STATE OF MAINE
DEPARTMENT OF TRANSPORTATION
16 STATE HOUSE STATION
AUGUSTA, MAINE 04333-0016

January 22, 2018
Subject: Billings Bridge
Superstructure Replacement
State WIN: 022618.00
Location: **Paris**
Amendment No. 2

STATE OF MAINE DEPARTMENT OF TRANSPORTATION		PROJECT NO. STP-2261(800)		BRIDGE NO. 2979	
v h		WIN		022618.00	
BILLINGS BRIDGE OVER LITTLE ANDROSCOGGIN RIVER		OXFORD COUNTY		PARIS	
ABUTMENT NO. 1		DETAILS (1 OF 6)		SHEET NUMBER	
30		OF 57

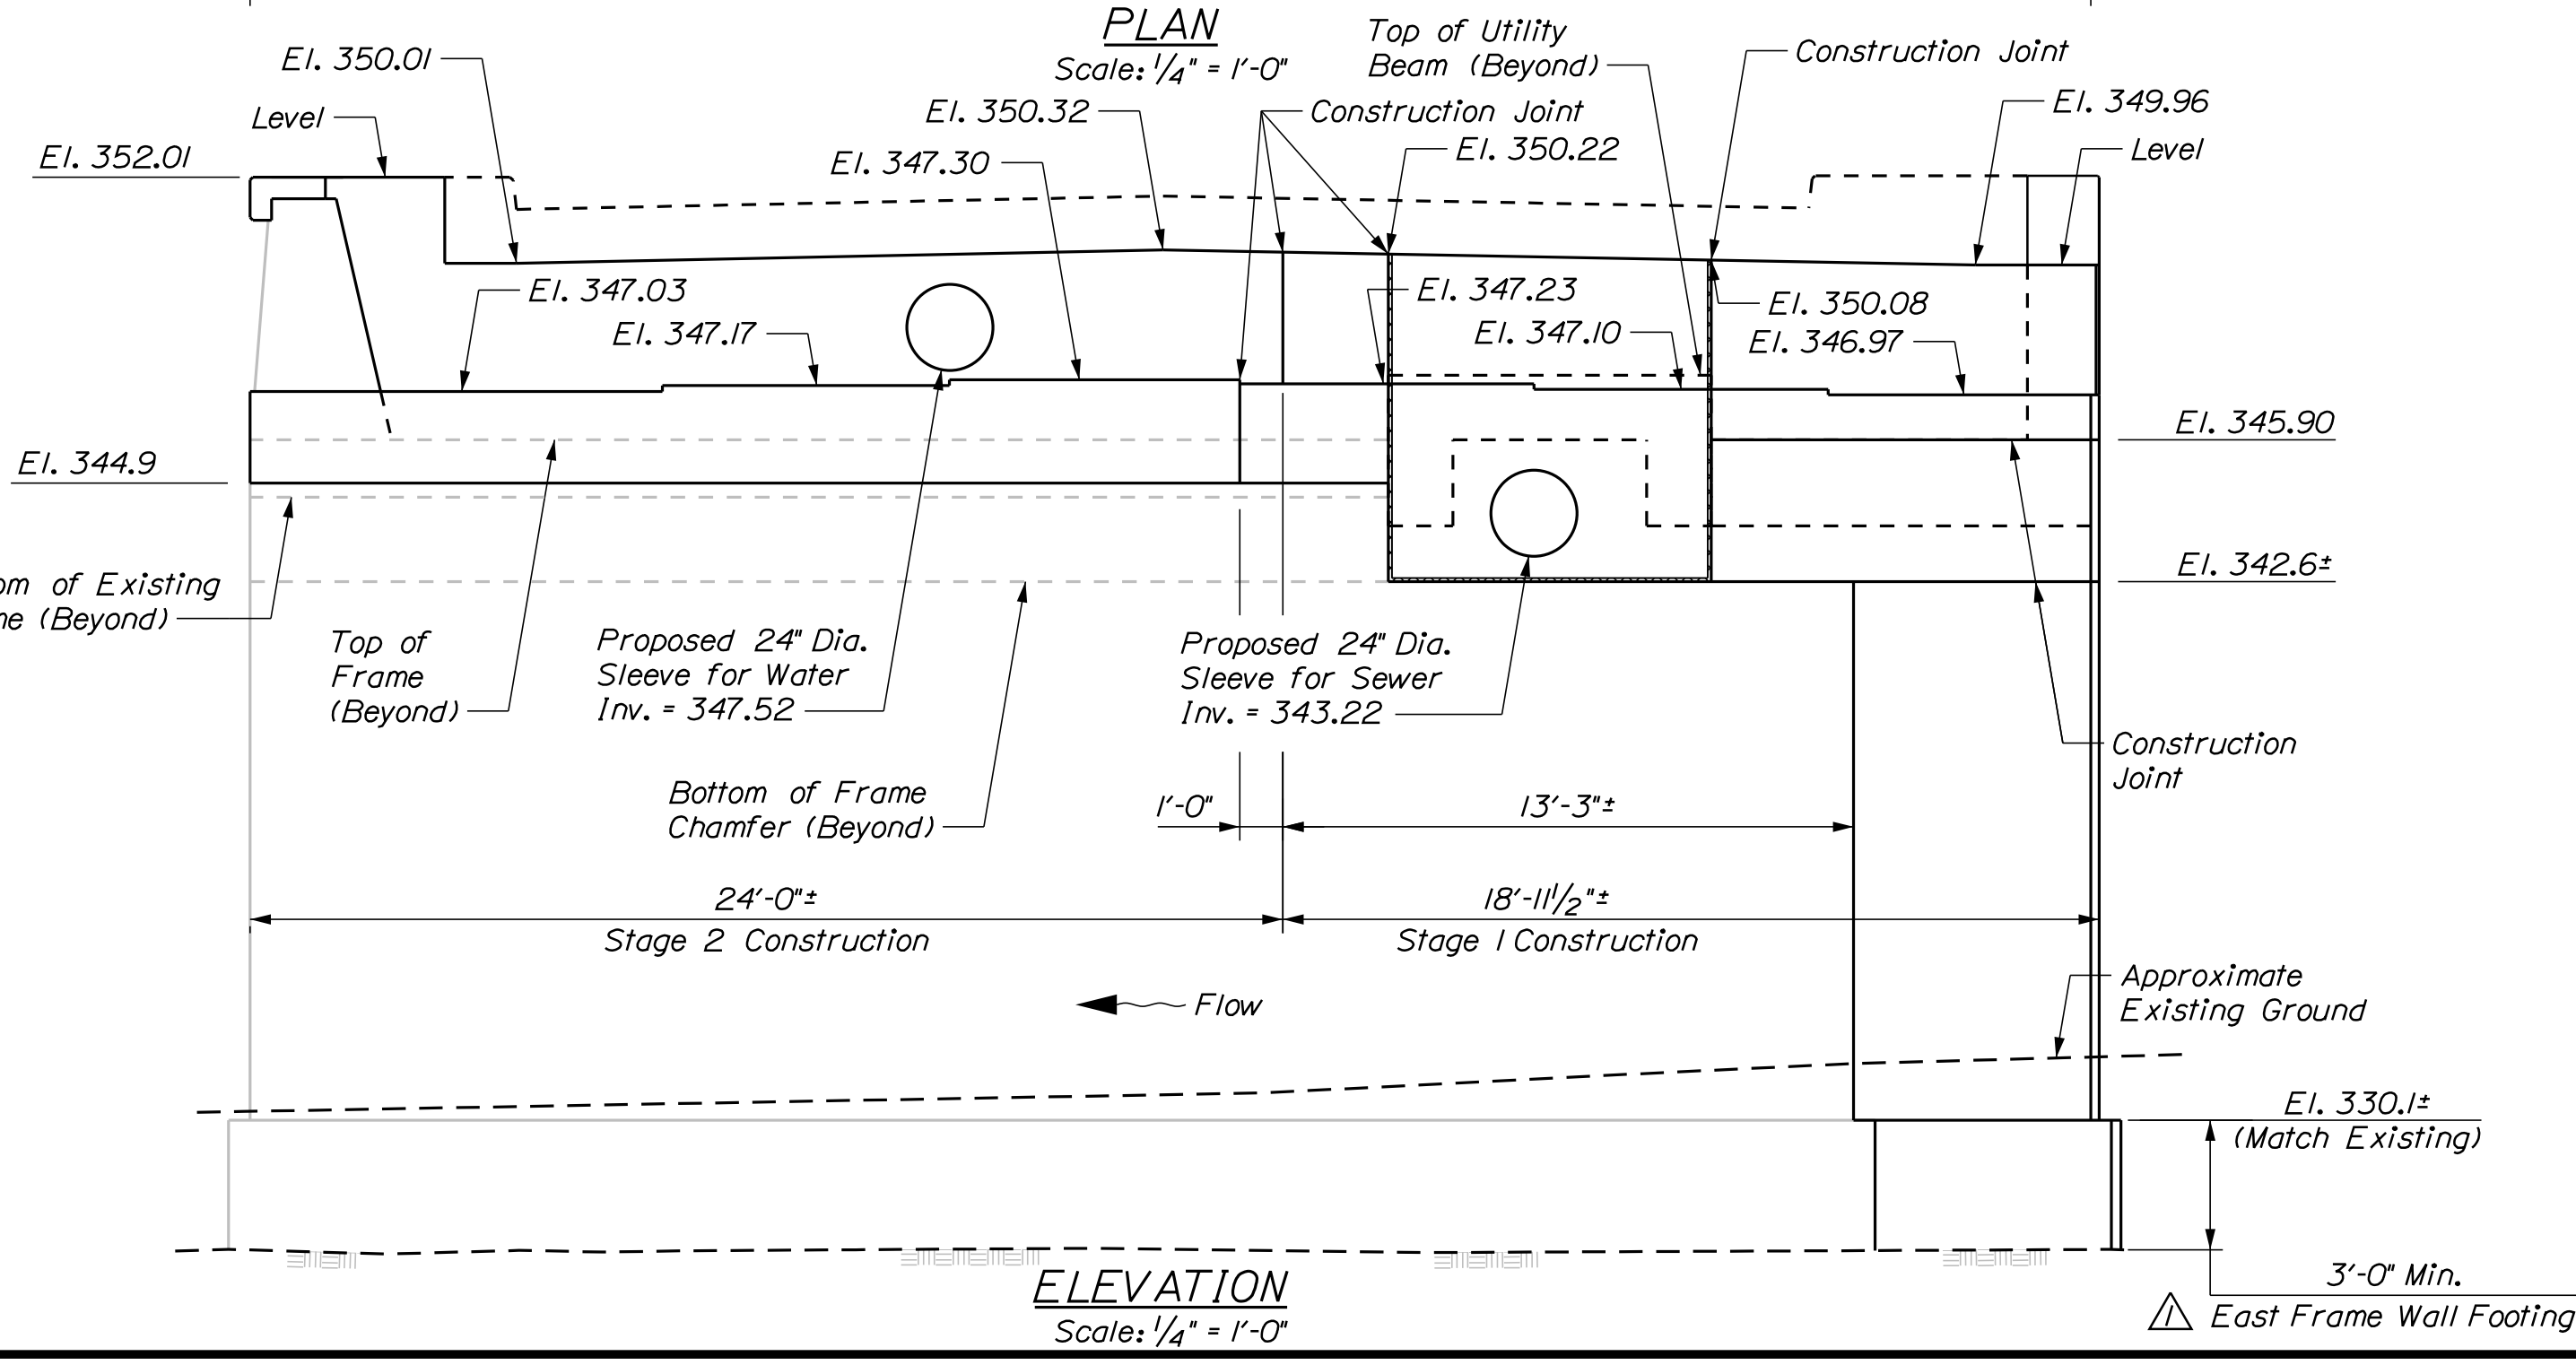
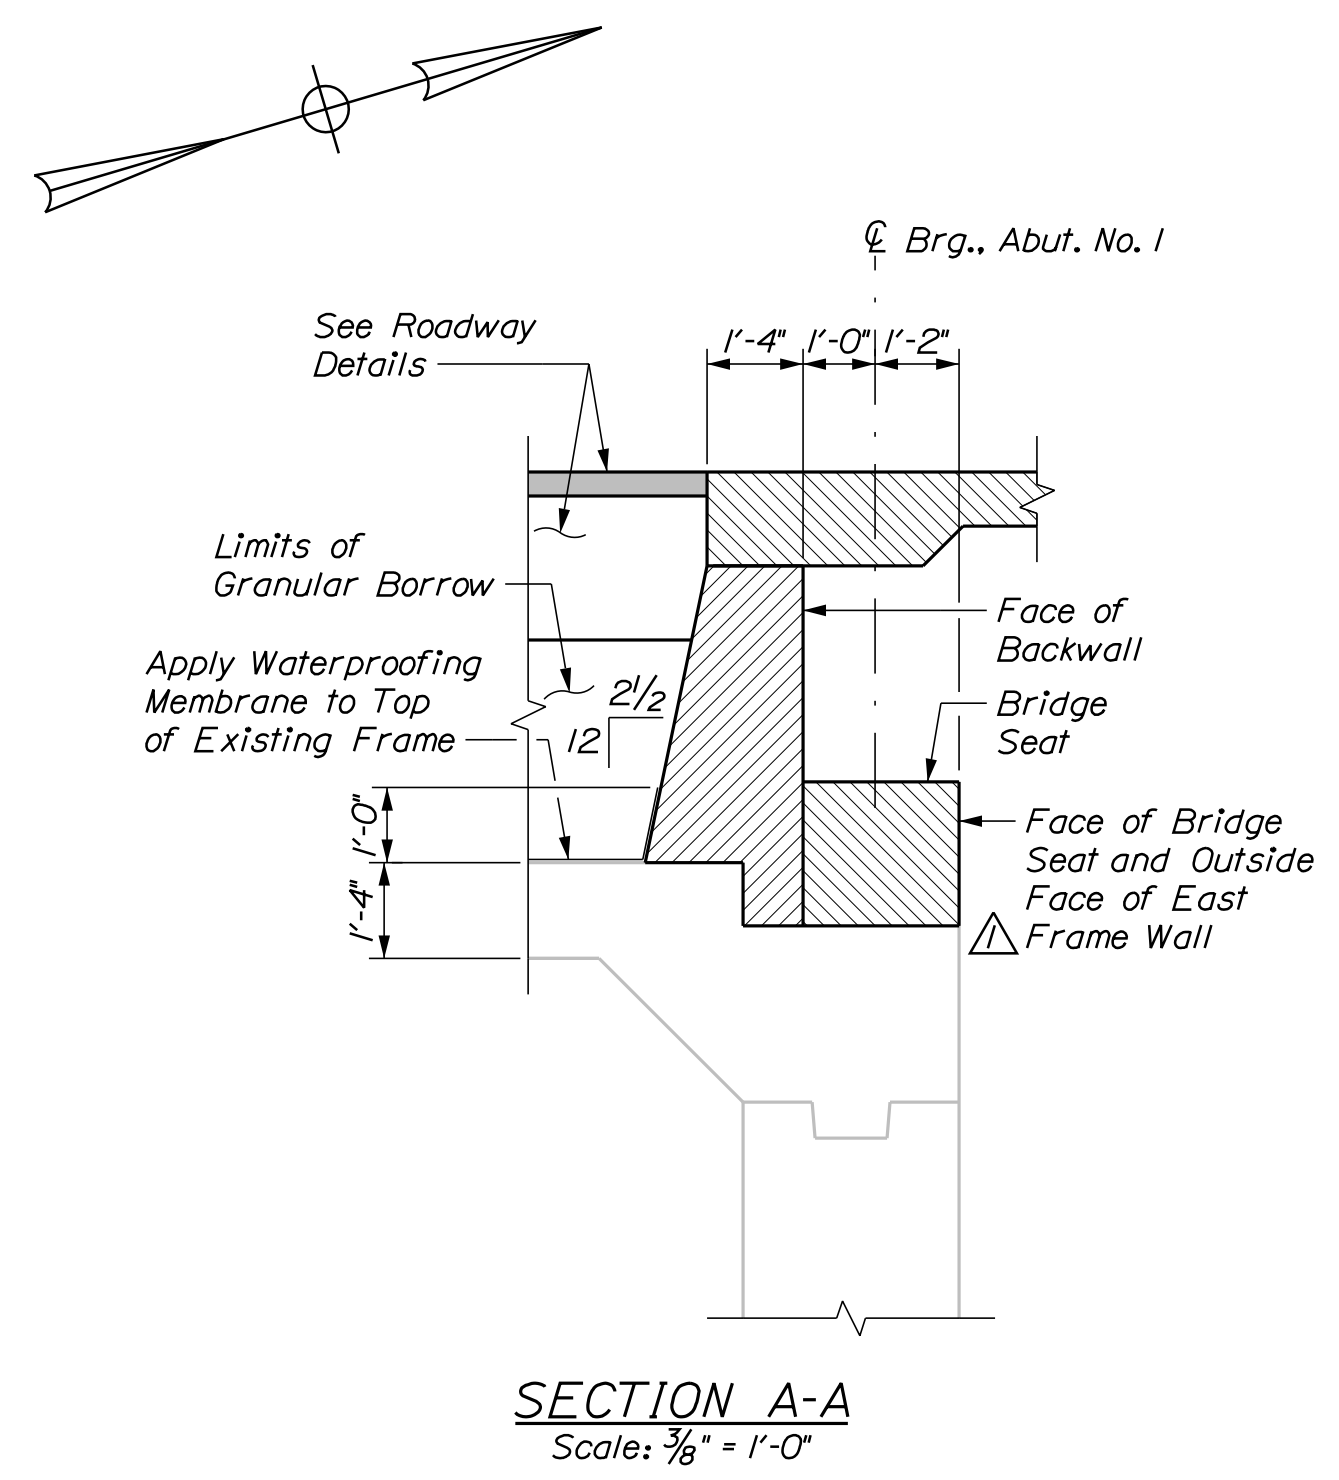
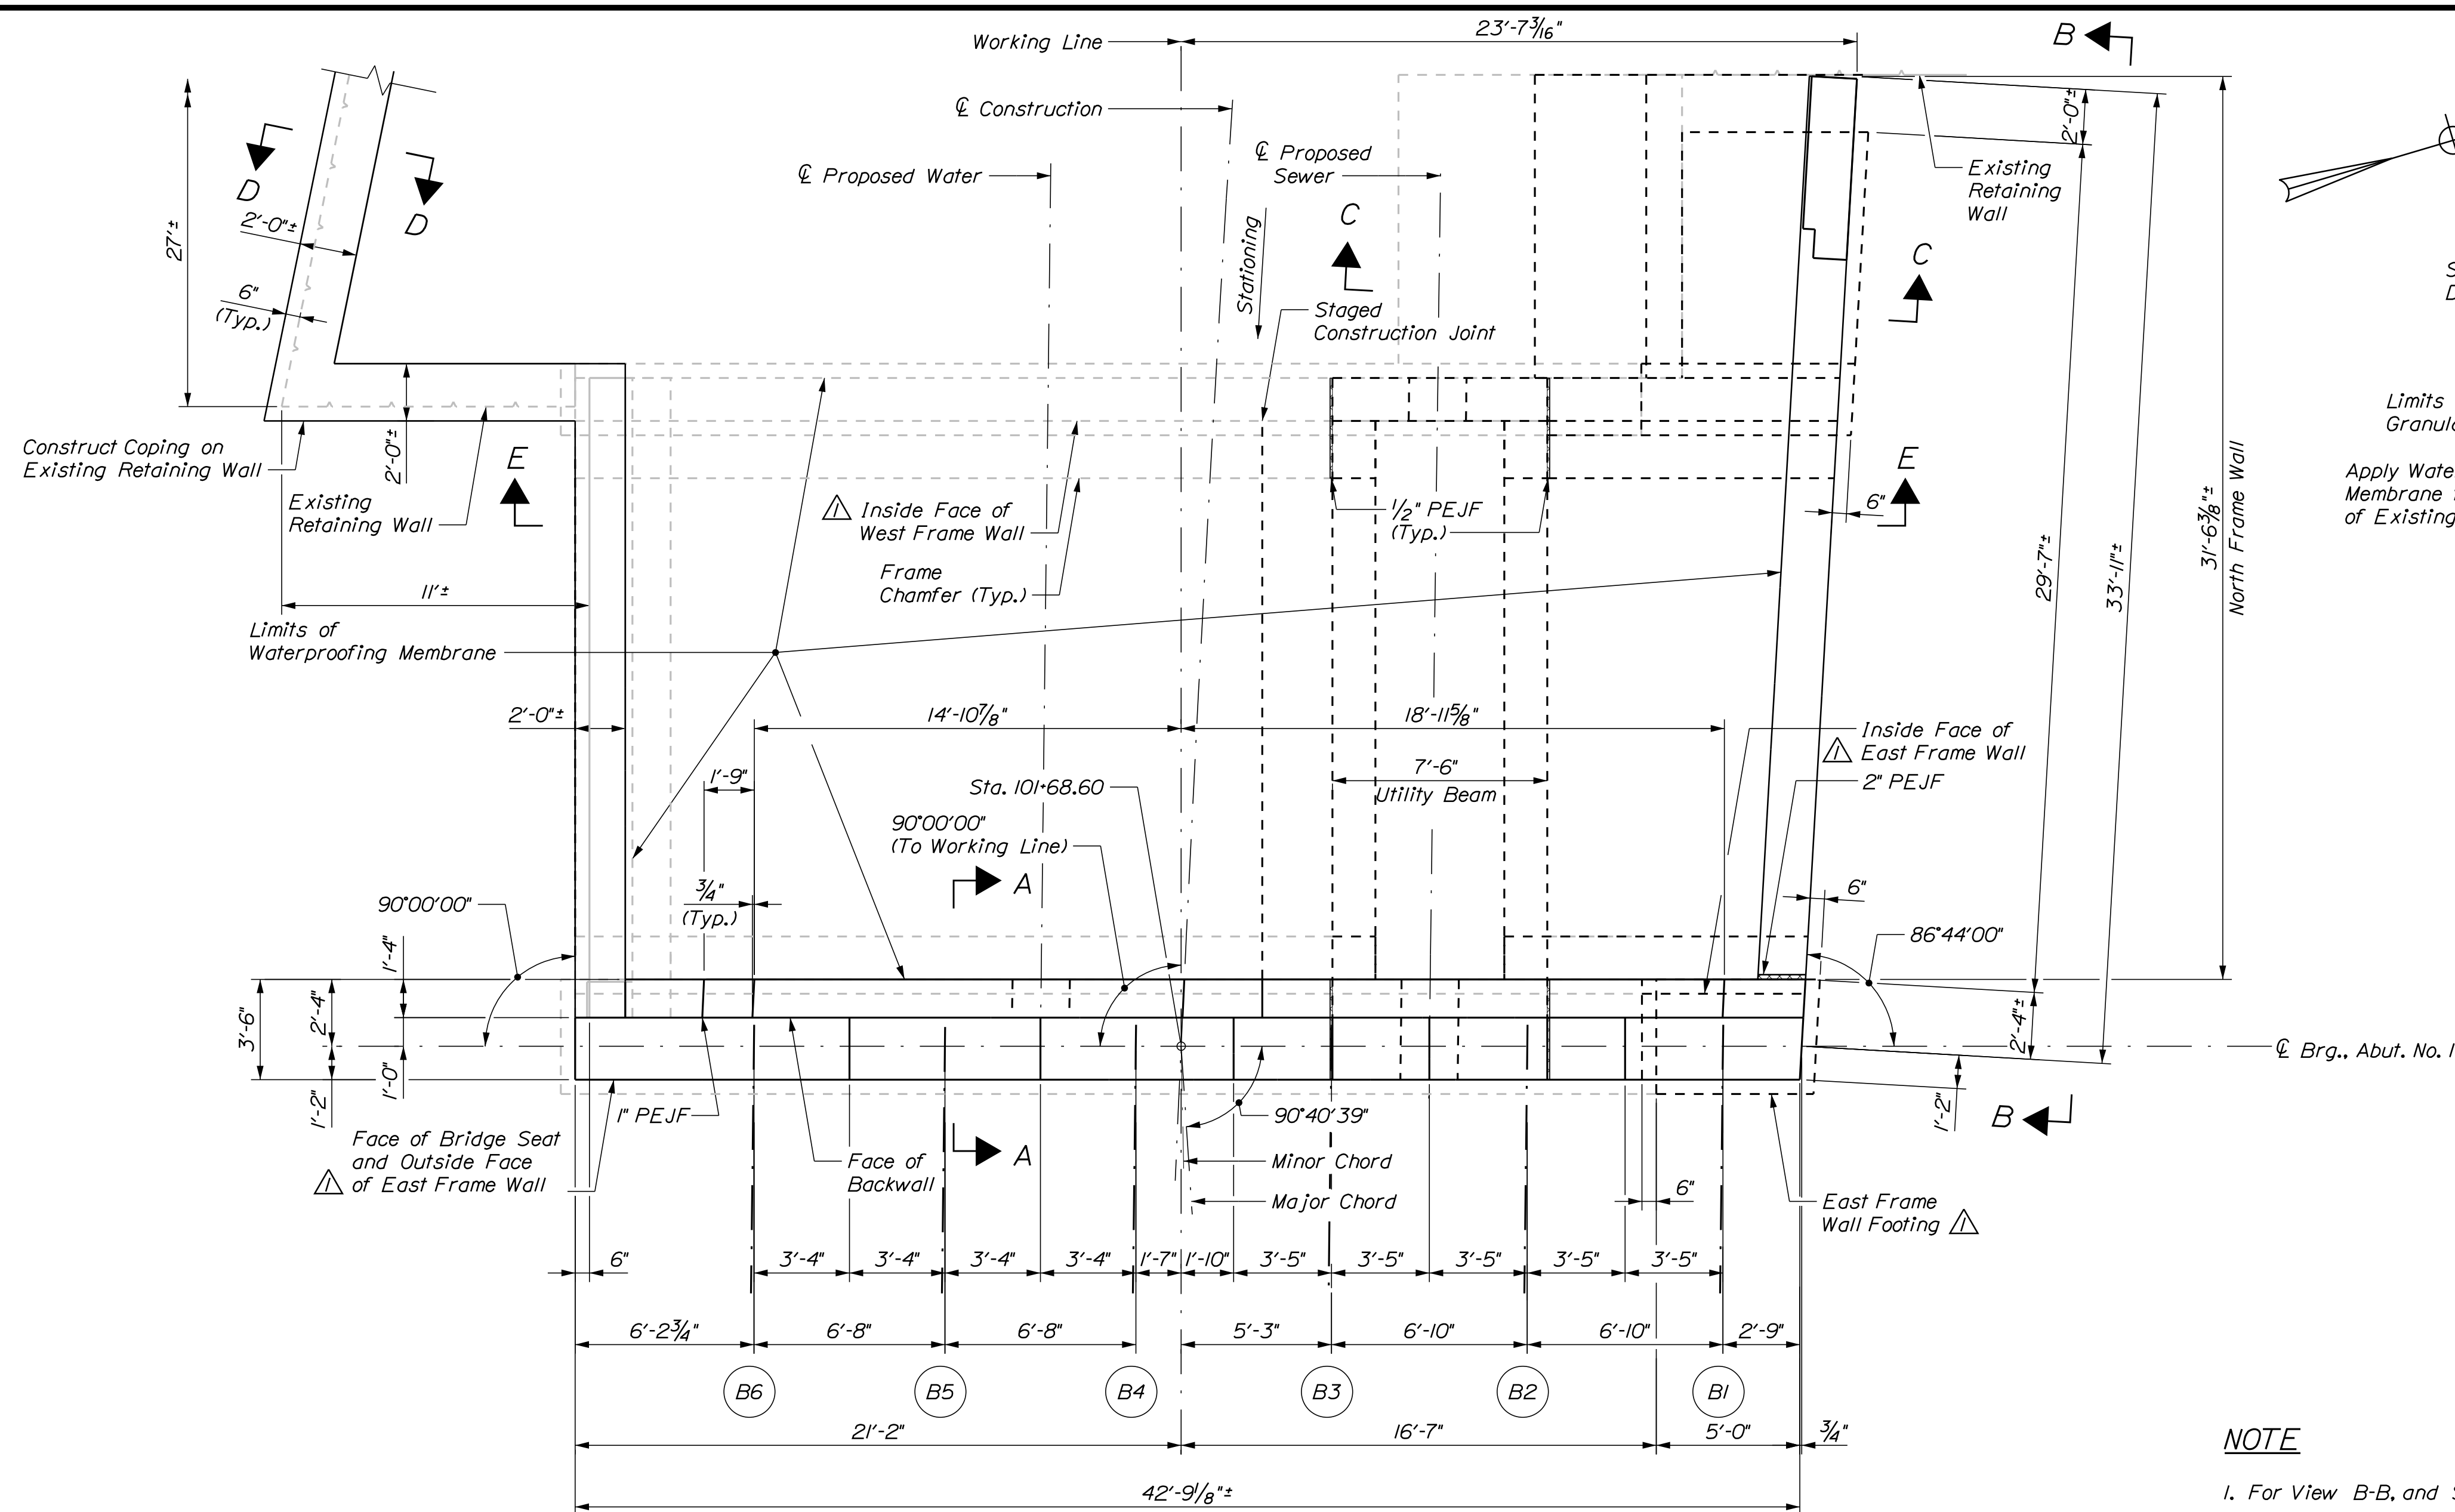
- 7. Remove bedrock as required to construct footing thickness to 3 foot minimum at the frame and 2 foot minimum at the wall. Bedrock elevations assumed based on existing plans. If bedrock is lower, fill void with concrete fill up to El. 327 at the frame and El. 329 at the wall, then construct footing above. Contractor to verify all existing elevations prior to construction.
